May 20, 2022

Industrial Device Business Division,  
Panasonic Industry Co., Ltd.

**Notice of wire mark removal from motor power cable  
of AC Servo Motor MINAS A6 / A5 / E Series**

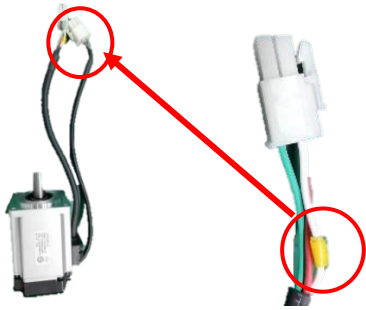
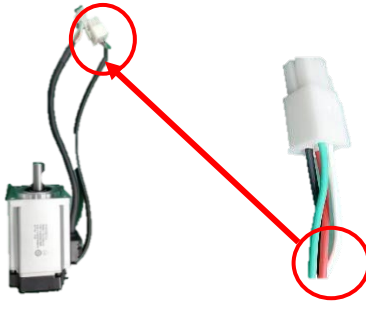
As described below, the wire mark on the lead wire type of motor power cable for AC servo motors with the 200 V voltage specification will be removed.

Before Change	After Change
Description of the Change	 <p align="center">White cable <b>with</b> yellow tape</p>	 <p align="center">White cable <b>without</b> yellow tape</p>

- There is no effect on product performance, compatibility, or reliability.  
There is also no change to part numbers.
